S1C17 Family Technical Manual Errata

ITEM A part of shipping form is discontinued			
Object manual	Document code	Object item	Page
S1C17121 Technical Manual	411723702	Configuration as shipped	1-2
1.1 Features			
(Error)			
● Configuration as shipped		<ul style="list-style-type: none"> • TQFP14-100 12 mm x 12 mm body, 0.4 mm pitch • VFBGA7H-144 7 mm x 7 mm, body, 0.5 mm pitch • Bare chip 100 μm pitch 	
(Correct)			
● Configuration as shipped		<ul style="list-style-type: none"> • TQFP14-100 12 mm x 12 mm body, 0.4 mm pitch • VFBGA7H-144 7 mm x 7 mm, body, 0.5 mm pitch # 1 • Bare chip 100 μm pitch <p># 1 : VFBGA7H-144 is discontinued.</p>

P26-1(S1C17711)

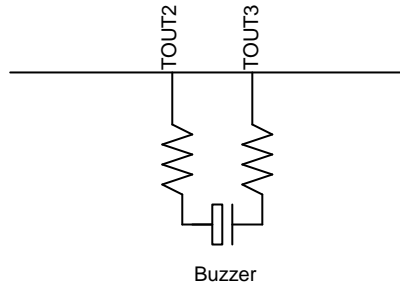
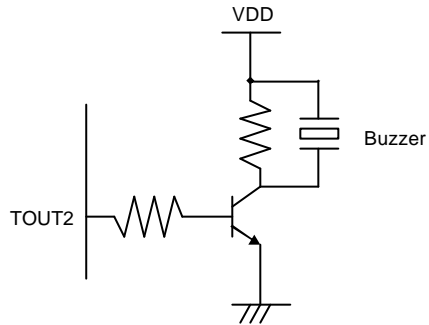
(Error)

(Correct)

P29-1(S1C17121, S1C17601, S1C17611)

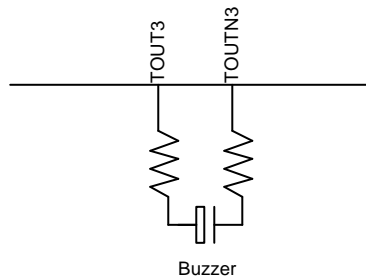
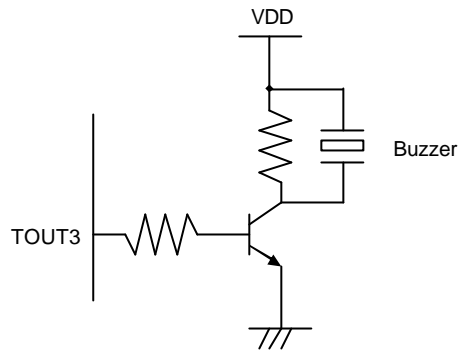
(Error)

(Correct)

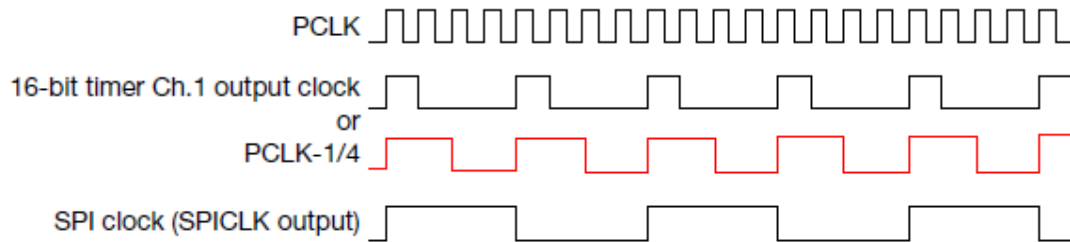
ITEM: SPI Clock		
Object manuals	Document code	Object number
S1C17121	411723700	P19-3
S1C17702	411581700	P19-3
S1C17003	411635100	P19-3
S1C17601	411805700	P19-3
S1C17611	411882300	P19-3
S1C17705	411706600	P15-2
S1C17621/S1C17602/S1C17622/ S1C17604/S1C17624	411914900	P19-3
P19-3(S1C17602,S1C17121,S1C17702,S1C17003,S1C17601,S1C17611)		
<p>(Error)</p> <p>The Master mode SPI uses the internal clock output by the 16-bit timer Ch.1 as SPI clock. This clock is output from the SPICLK pin to slave device while also driving the shift register. Use the MCLK(D9/SPI_CTL register) to select to use the 16-bit timer ch.1 output clock or PCLK-1/4 clock. Setting MCLK to 1 selects the 16-bit timer Ch.1 output clock; setting to 0 selects to 0 selects the PCLK-1/4 clock.</p> <p>*MCLK: SPI Clock Source Select Bit in the SPI Control(SPI_CTL)Register(D9/0x4326)</p> <p>Using the 16-bit timer Ch.1 output clock enables programmable transfer rates. For more information on 16-bit timer control, see "11 16-bit Timer(T16)."</p>

The Master mode SPI uses the internal clock output by the 16-bit timer Ch.1 as SPI clock. This clock is output from the SPICLK pin to slave device while also driving the shift register. Use the MCLK(D9/SPI_CTL register) to select to use the 16-bit timer ch.1 output clock or PCLK-1/4 clock **is used**. Setting MCLK to 1 selects the 16-bit timer Ch.1 output clock; setting to 0 selects the PCLK-1/4 clock.

Figure 15.3.1 Master Mode SPI Clock

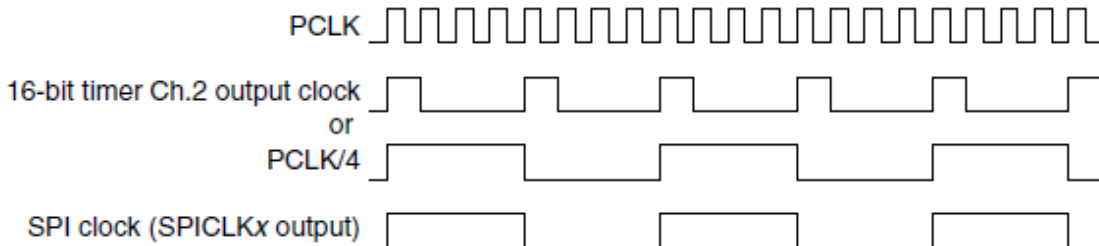
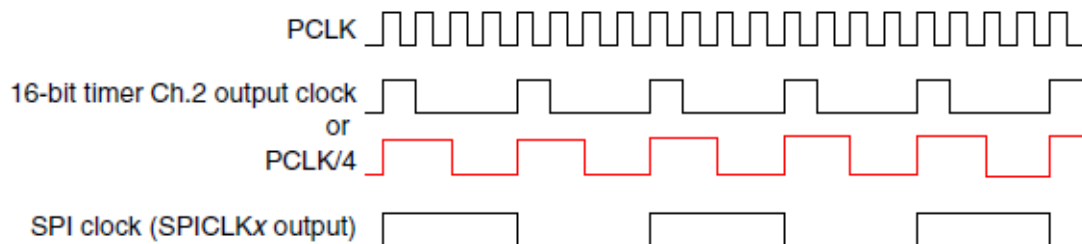
(Error)

(Correct)

Figure 19.3.1 Master Mode SPI Clock

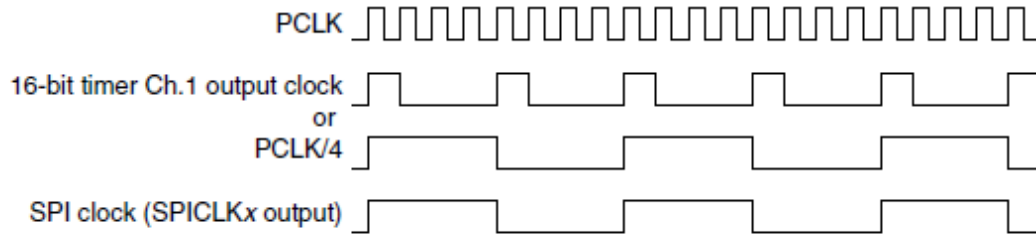
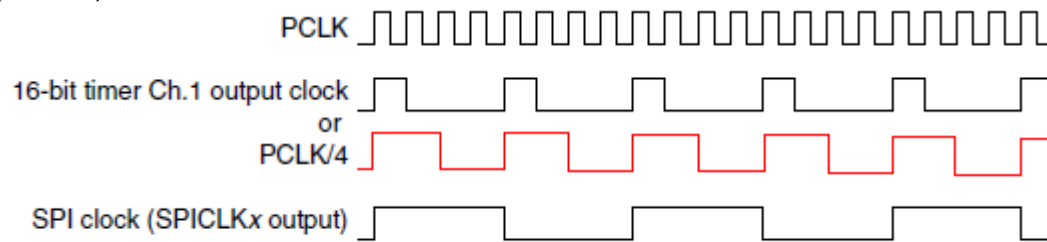
(Error)

(Correct)
